Q&A update for Constellation-X mandel RFI – January 08, 2007

The following questions (with answers) have been asked of the program by various participants; all are being posted on the project website at

Figure 1: Axial PSD from the RFI, scaled from that fitted from mirror segment data on multiple mirror segments (red, "Reid Model") and example "Average residual PSD" mandrel in use (black) with model (blue). Modeled performance of perfectly formed mirror segments from this mandrel is acceptable.

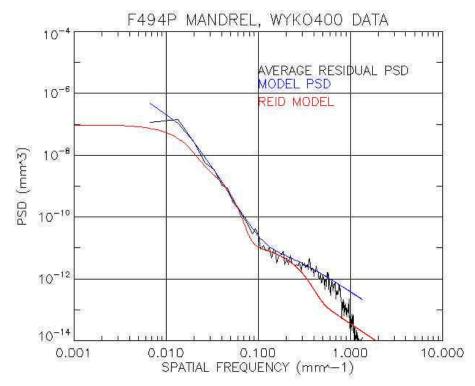
A. What is the reference power spectral density (PSD) [Fig. 2-2 of the RFI] based on? On an existing mandrel or theoretical calculations? The slopes of up to -7 are very challenging.

The reference PSD is actually based on a composite fit to the technology development mirrors made from the current mandrels in use. The fitted PSD for the segment is scaled (reduced) proportionately to the portion of the error budget which has been allocated for mandrel fabrication errors.

The mandrel is treated to promote release after thermal forming and is rough at high spatial frequencies (spatial periods below ~2mm). The glass being formed is intrinsically smooth at high frequencies and so the mandrel is not directly required to be smooth at high frequencies as delivered. We documented a requirement of ~1nm rms simply as that is what we know will work with the current process. It may be that rougher mandrels would be consistent with the current process.

To aid responders, we now provide a PSD of mandrels in use and integrated (axial only) rms statistics over bandpasses. While we are sure that these mandrels are not limiting performance, we do not have enough information to fully specify mandrels. PSD slopes are still high for these mandrels in some spatial frequency ranges, but these were not difficult to manufacture.

The (axial, one-dimensional) PSD shown here is based on papers by Eugene Church and has the form

$PSD = (a/[1+(b f)^2]^(c/2)$

where a, and b scalar constants have dimensions mm<sup>3</sup> and mm respectively; c is the (dimensionless) slope.

A fit to the mandrel PSD using a low and high frequency portion results in these values:

Integration of this model over the bands 100-1mm and 1-0.001mm gives rms surface error values of 33nm and 0.6nm respectively.
